COMMONWEALTH OF KENTUCKY
BEFORE THE PUBLIC SERVICE COMMISSION

ELECTRONIC 2018 JOINT INTEGRATED)	
RESOURCE PLAN OF LOUISVILLE GAS AND)	
ELECTRIC COMPANY AND KENTUCKY)	CASE NO. 2018-00348
UTILITIES COMPANY)

RESPONSE OF
LOUISVILLE GAS AND ELECTRIC COMPANY
AND
KENTUCKY UTILITIES COMPANY
TO COMMISSION STAFF'S FIRST REQUEST FOR INFORMATION
DATED OCTOBER 3, 2019

ii. Cumulative totals to correspond to Figure 2. Please note that 2017 in the figure below has been updated for actuals in 2017. Figure 2 in Exhibit GSL-1 had projected values for 2017.

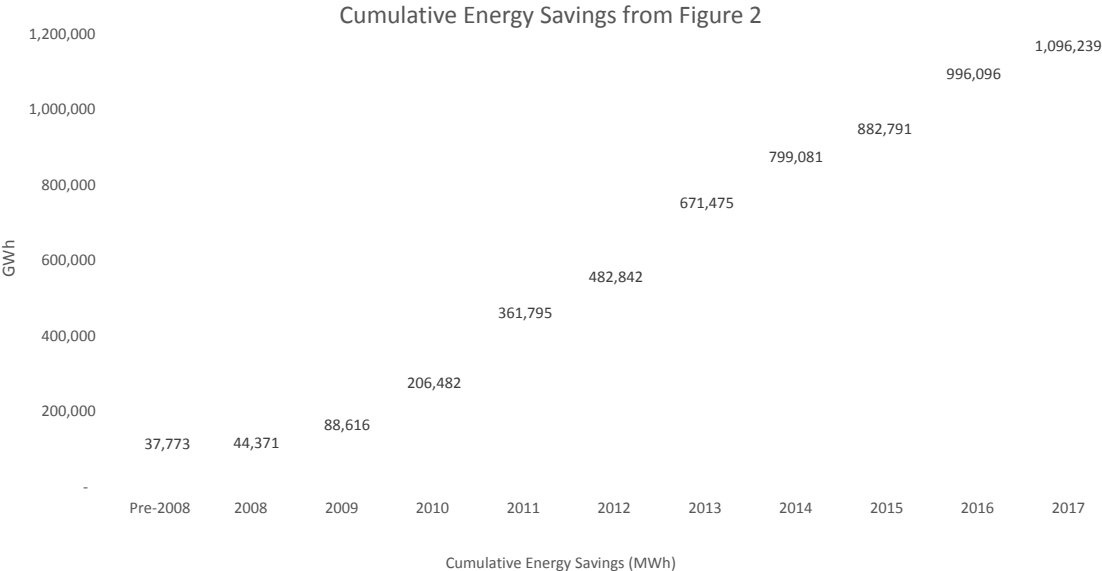
- a. Provide the incremental energy and demand savings associated with each of the years 2013-2017.
- b. Refer to application in Case No. 2017-00441,⁵ the Direct Testimony of Gregory Lawson, Exhibit GSL-1, pages 4 and 5 of 182, Figures 1 and 2, respectively.
 - i. For Figure 1, explain the apparent differences between the listed annual demand savings and the annual savings calculated from the cumulative savings line.
 - ii. For Figure 2, provide a chart with the associated cumulative totals as was provided in Figure 1.
- c. Provide an explanation of the differences between the annual and cumulative energy and demand savings inherent in IRP Table 7-14 and those in Figures 1 and 2.

- b.
 - i. The demand and energy savings of Smart Energy Profile (SEP) and Kentucky School Board Association (KSBA) programs do not accumulate across years as a simple total. SEP and KSBA programs utilize a one-year measure-life of savings. The cumulative amount is calculated as the sum of the previous year plus the incremental savings less the prior year’s savings attributed to SEP & KSBA.

Figure 1: Generation Technology Cost Forecast (2017 Dollars)¹³

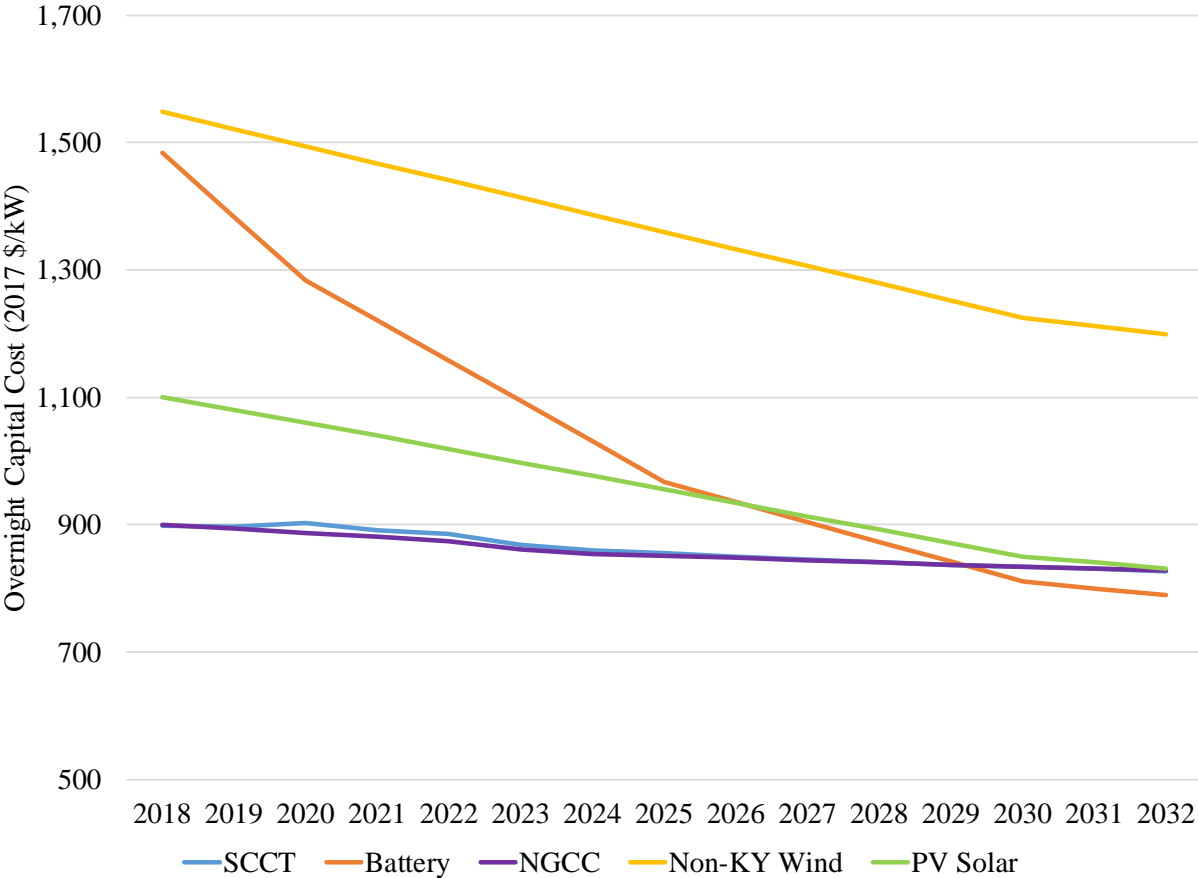
Q-35. Refer to the IRP, Volume 3, 2018 IRP Resource Screening Analysis (Resource Screening Analysis), page 4, Table 1. Refer also to the Resource Screening Analysis, page 5, Figure 1. Provide an updated Table 1 and Figure 1 using cost data from the National Renewable Energy Laboratory's 2019 Annual Technology Baseline.

A-35. Table 1 and Figure 1 below have been updated using cost data from NREL's 2019 ATB.
